DATA REQUEST RESPONSES

**SOLAR ENERGY GENERATING SYSTEMS (SEGS) VIII AND IX
(88-AFC-01C AND 89-AFC-01C)
BATTERY ENERGY STORAGE SYSTEM**

September 2019

The following are the responses to the data requests, Set 1, received from the California Energy Commission (CEC) in a letter dated August 26, 2019 for the Solar Energy Generating Systems (SEGS) VIII and IX Petition for Post Certification Change to add Battery Energy Storage System (BESS). Attachment A of this document contains the CEC Data Request letter.

TERRA-GEN	JOB NUMBER	REV
	SEGS VIII BESS & SEGS IX BESS		1
	Figure 1: One Line Diagram	DRAWING NUMBER	SEGB-1

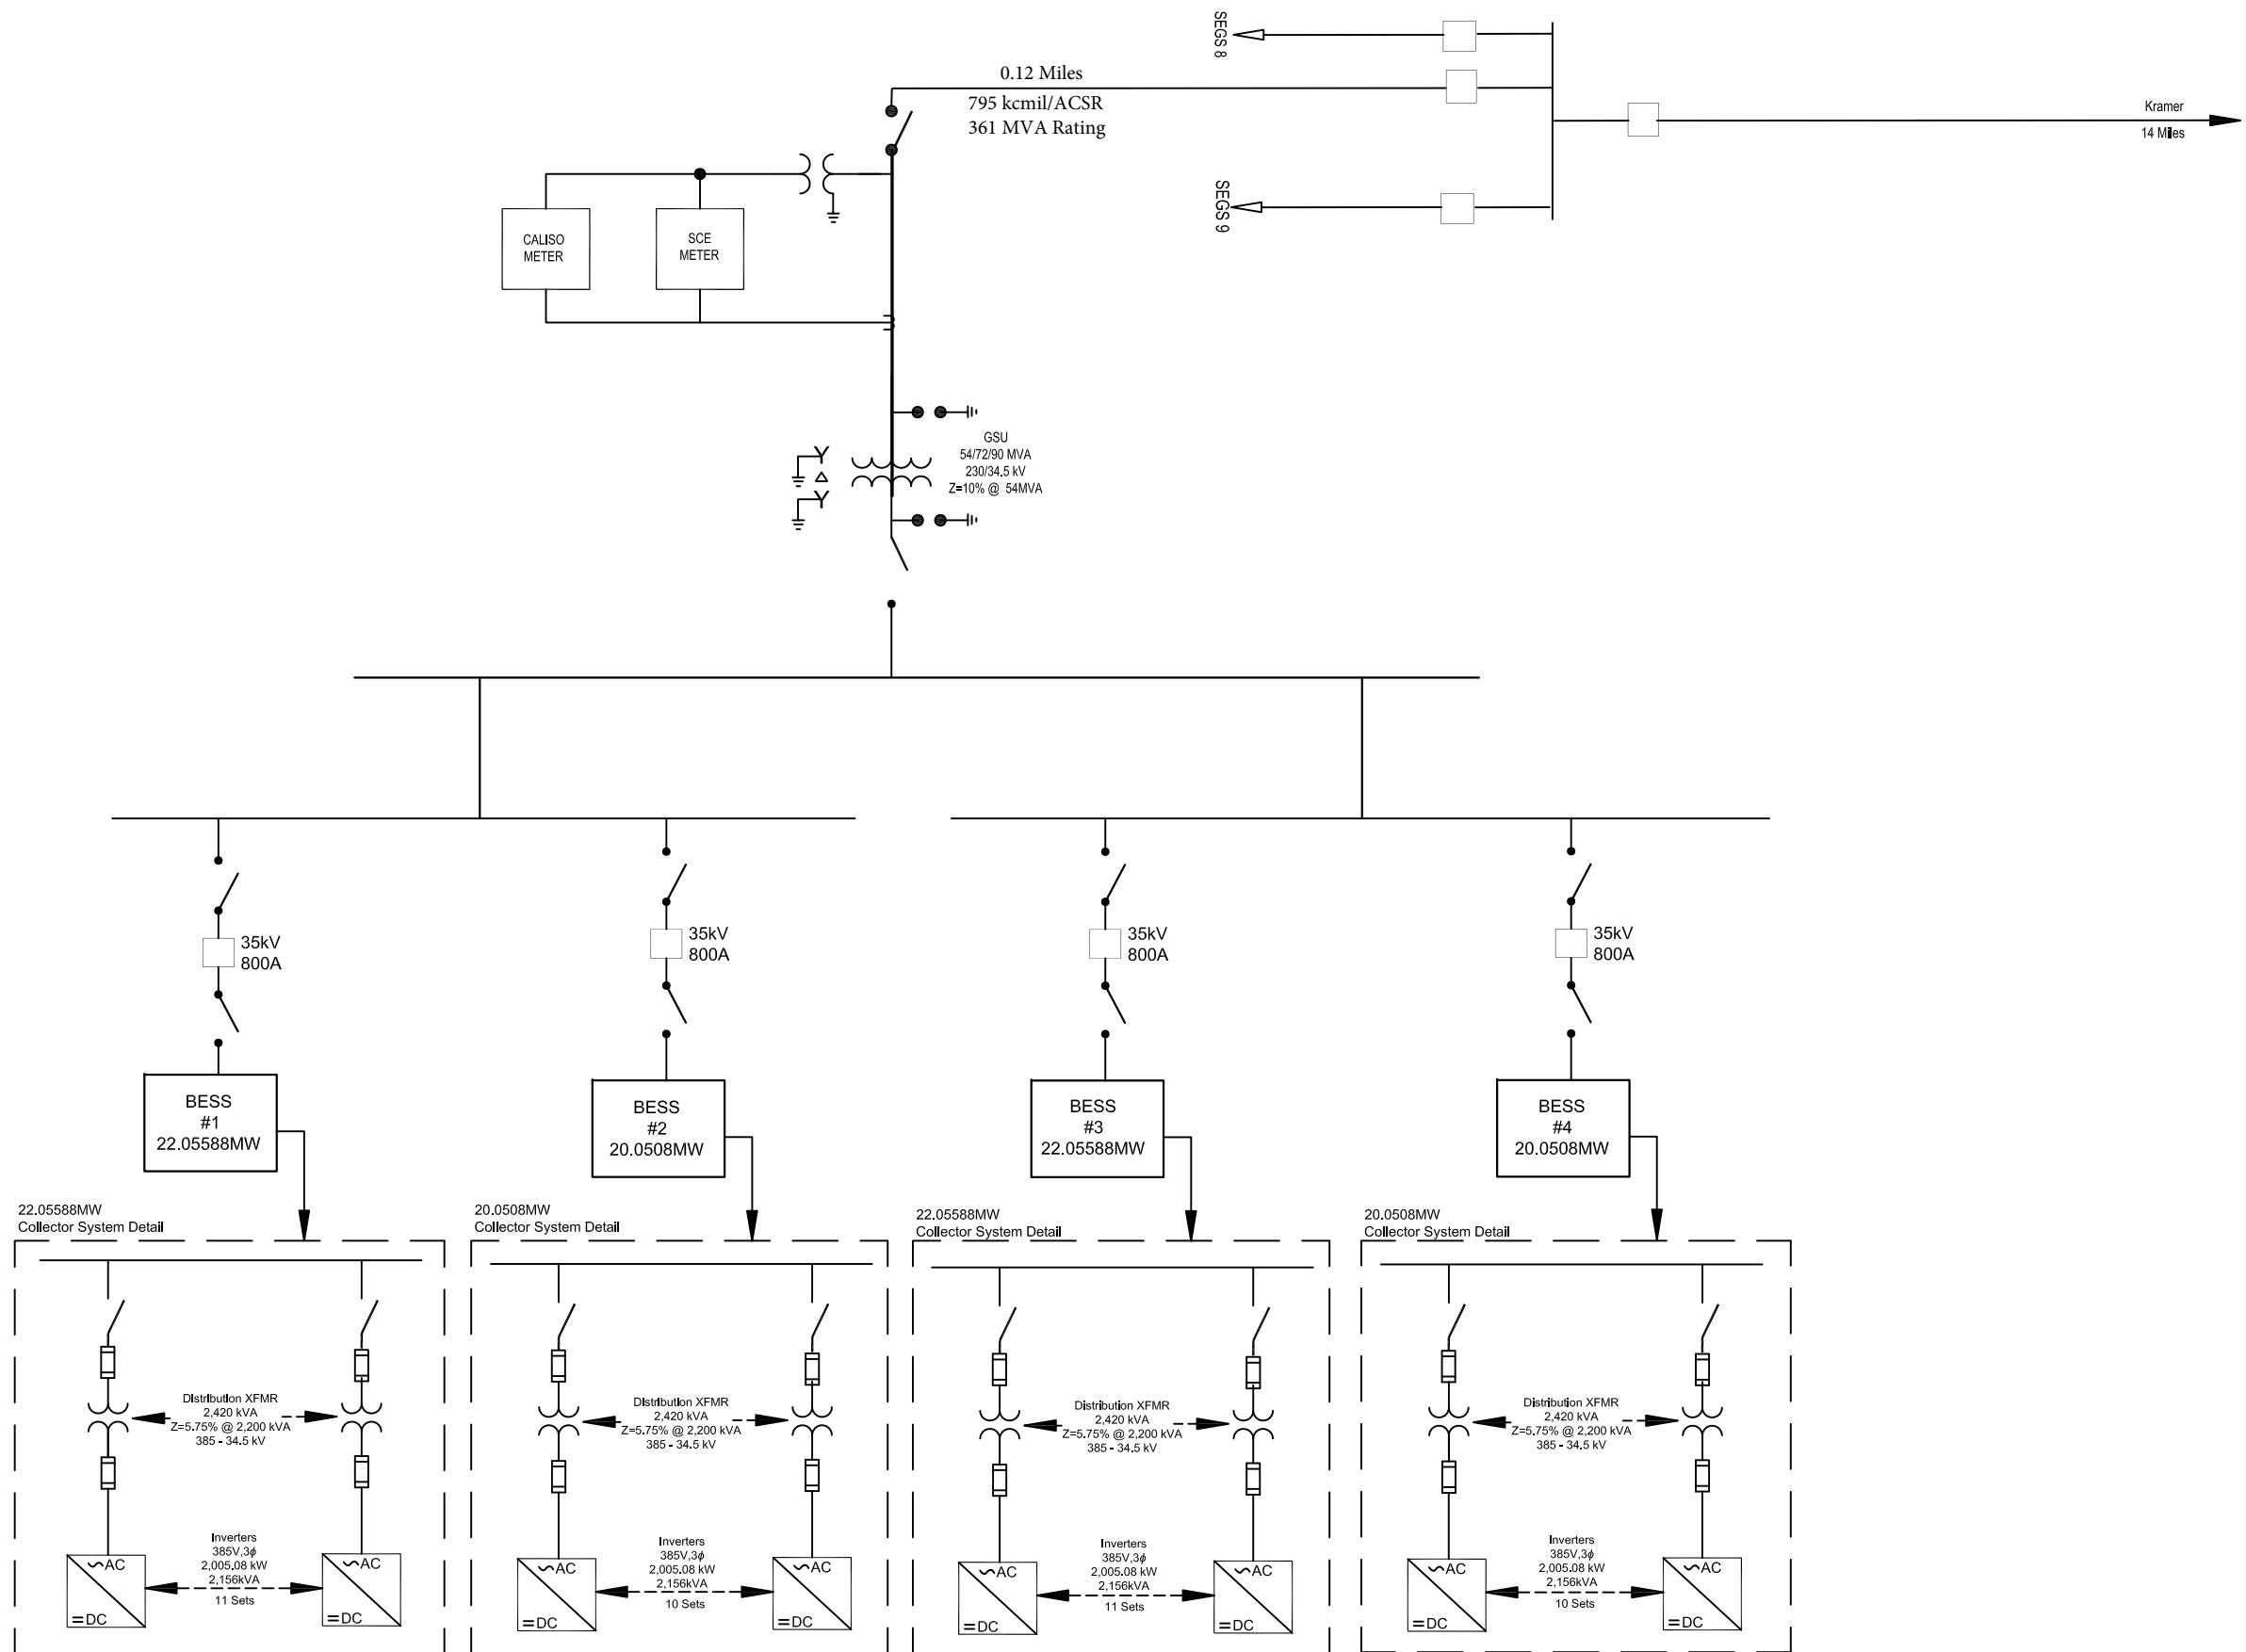
Data Request A2: *Please provide one-line diagrams of the BESS with detailed information on how it would be interconnected with the existing SEGS VII and SEGS IX plant substations.*

See attached Figure 1, One-Line Diagram.

Figure 2: SEGS Configuration – Overall Plant View

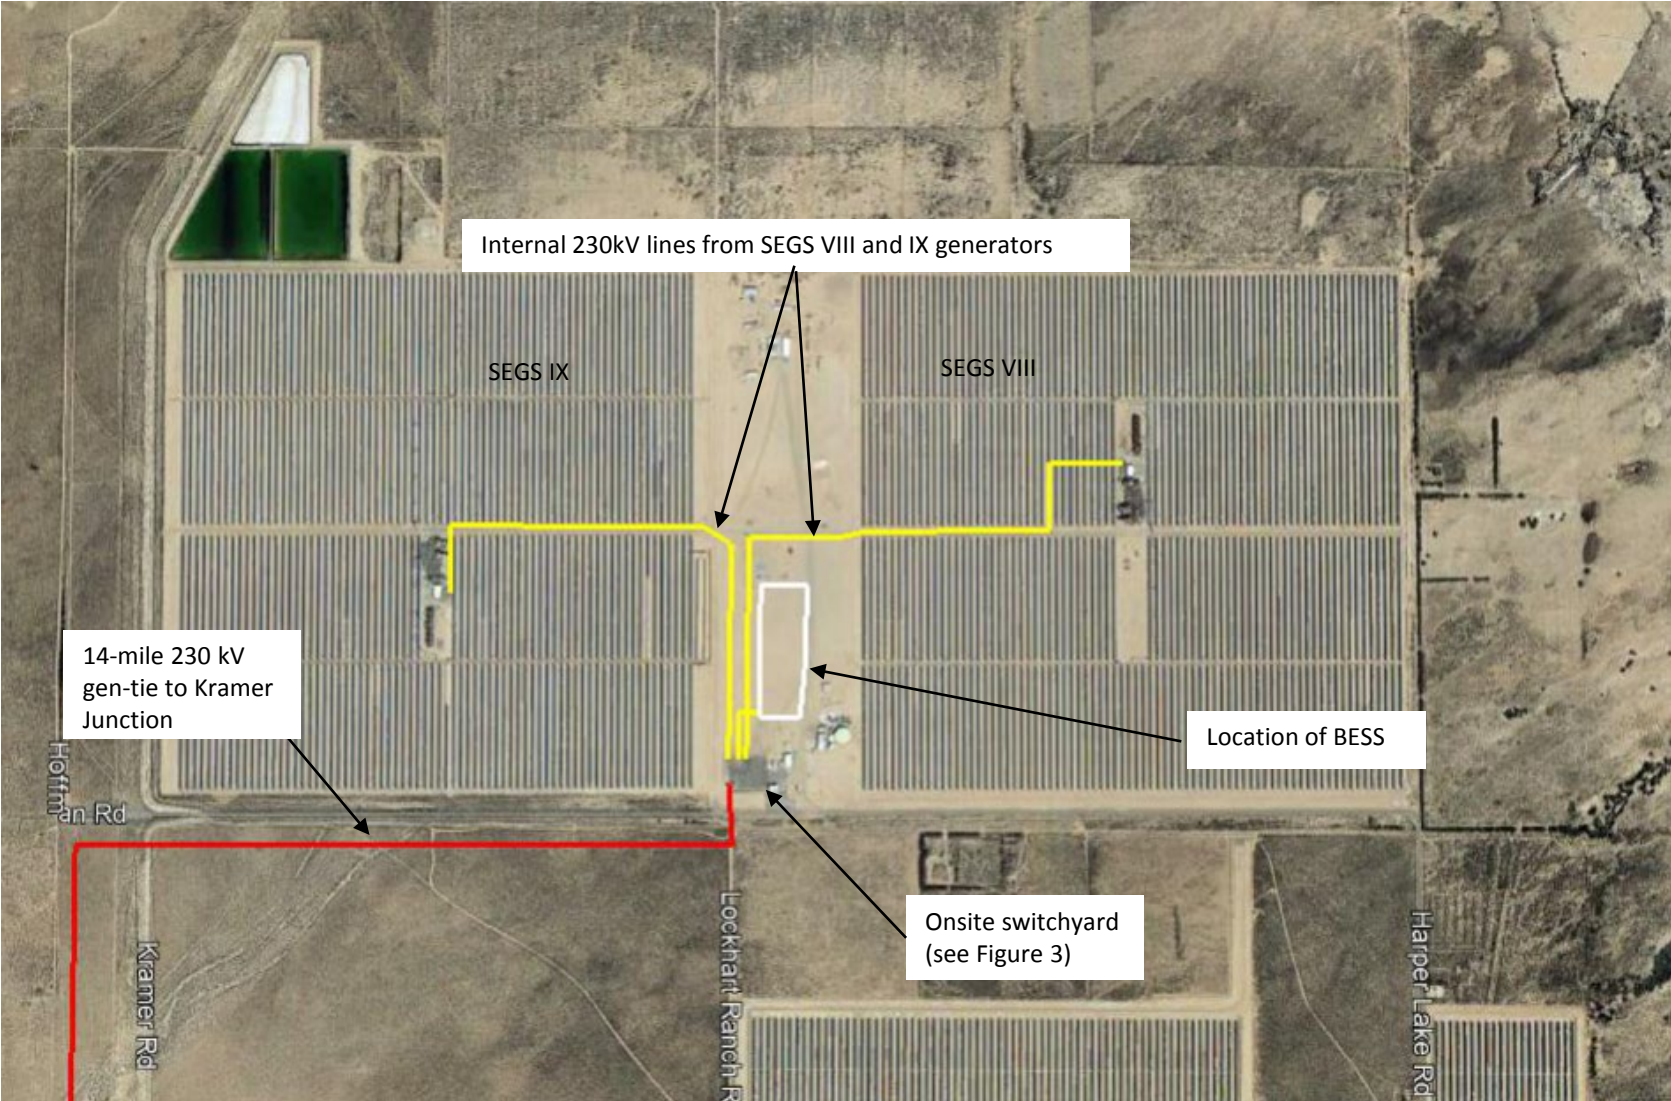
Data Request A3: *Please provide detailed schematic diagrams of the SEGS VIII and SEGS IX and their interconnections to the proposed BESS and to the California ISO - controlled grid. Please indicate the feeder ratings such as DC voltages, conductor type and size and current carrying capacity, and fuse/breaker coordination information.*

See attached Figure 2 and 3 that show an aerial view of the existing plant high voltage electrical transmission systems and the proposed location of the modification to the on-site switchyard to accommodate the BESS. The BESS system will connect to the existing plant switchyard by adding a new breaker and switches connecting to a common bus with the existing SEGS VIII and IX units. Please refer to the Figure 1, One-Line Diagram, for voltages, ratings, and configuration of the combined BESS and SEGS VIII and IX units.
